Docket No. 50-231

In letters dated July 8 and September 3, 1970, you applied for Change No. 3 and Change No. 4, respectively, to the Technical Specifications appended to Provisional Operating License No. DR-15 for the Southwest Experimental Fast Oxide Reactor (SEFOR). Proposed Change No. 3, as amended, would authorize the use of guinea pig rods in the inner positions of the core during steady-state operation up to 20 MWt and during excursion testing, including the maximum planned transient. Proposed Change No. 4 was submitted in response to the requirements of Technical Specifications 3.10.E and 6.6.B.3 which require, prior to operation above 17.5 MWt and excursion testing, proposal of additional specifications that: (a) provide specific criteria for judging the acceptability of continued operation with loss of fuel clad integrity, (b) address necessary steps for the detection of loss of fuel clad integrity, and (c) provide quantitative definitions of limits of unexplained behavior of pertinent reactor parameters. Amendments to the proposed changes were contained in your letters dated September 8, December 11, 22 and 31, 1970; January 28 and February 1, 1971. In addition, on Decem

Figure 2.1-1.

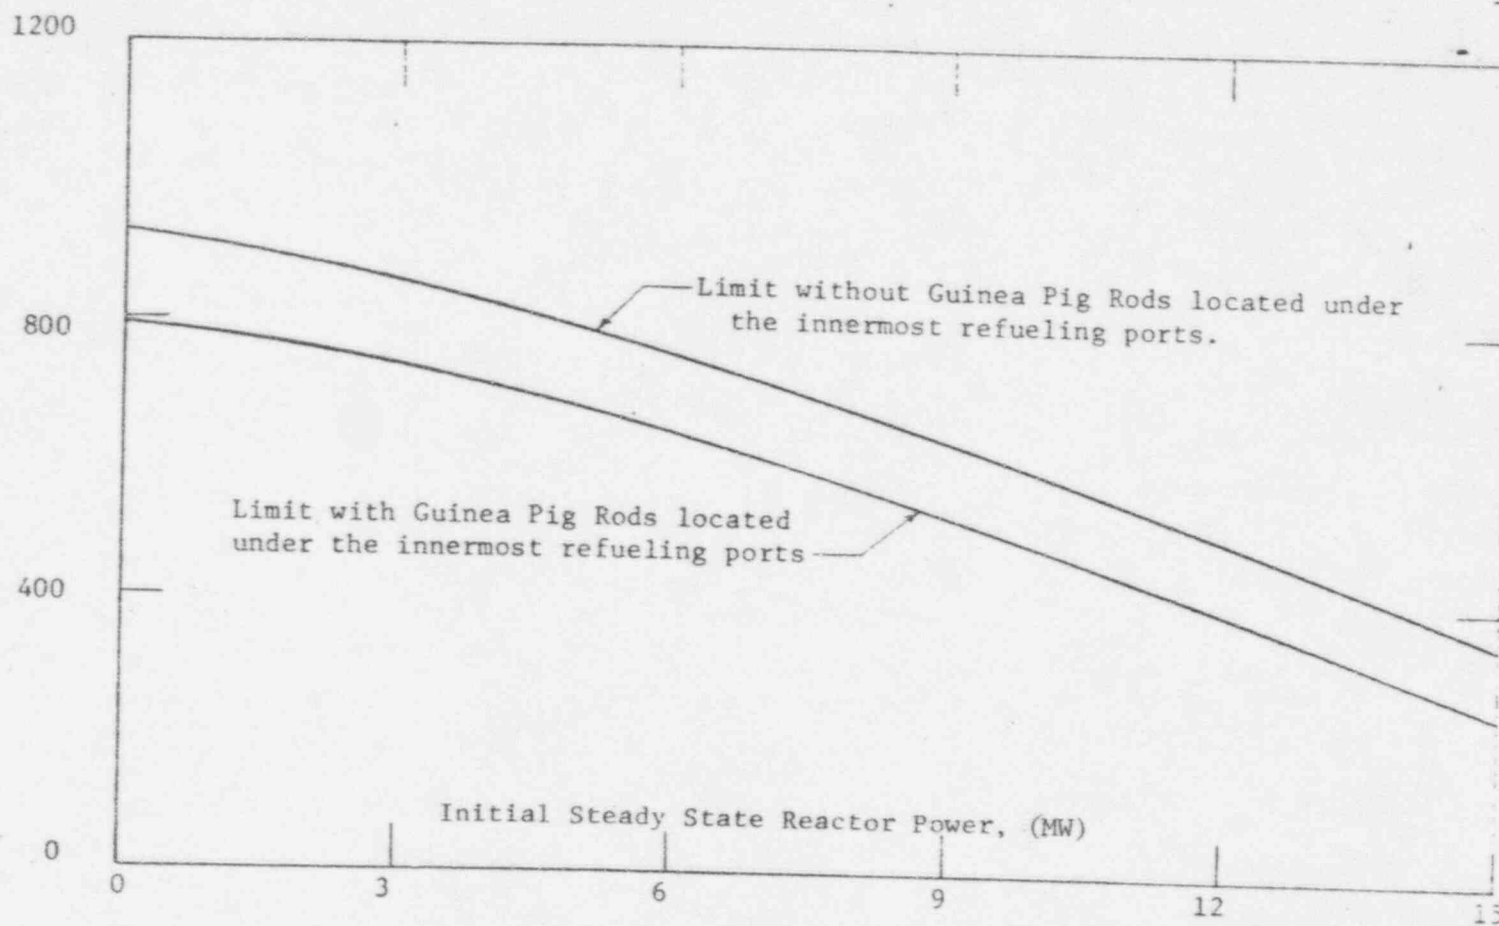
- B. The maximum permissible reactor core flux during an excursion test after the FRED is fired shall be  $6.25 \times 10^3$  times rated flux.
- C. The maximum permissible integrated energy deposited in the core during an excursion test shall not exceed the limit shown in Figure 2.1-1. The limit is exceeded when reactor conditions result in a point above the limit line.

The two curves shown on Figure 2.1-1 define the total energy which can be deposited in the core during a planned transient with and without guinea pig rods present under the innermost refueling ports without exceeding a peak fuel rod centerline energy density of 250 cal/g. The 250 cal/g value is the calculated energy density from mixed oxide fuel just below its solidus temperature as obtained using the latest available data for mixed oxide fuel heat capacity.<sup>(8)</sup> Results from transients tests<sup>(3,4)</sup> on sodium-cooled oxide fuel have demonstrated that repeated transients up to fuel energy densities of 250 cal/g will not damage the fuel. Initial fuel temperatures are based on the data and methods given in Reference 10. The difference between the two curves shown on Figure 2.1-1 is the result of differences in power peaking factor for the standard hot rod and the guinea pig rods which influence the initial fuel temperature and the energy deposited in a particular rod.
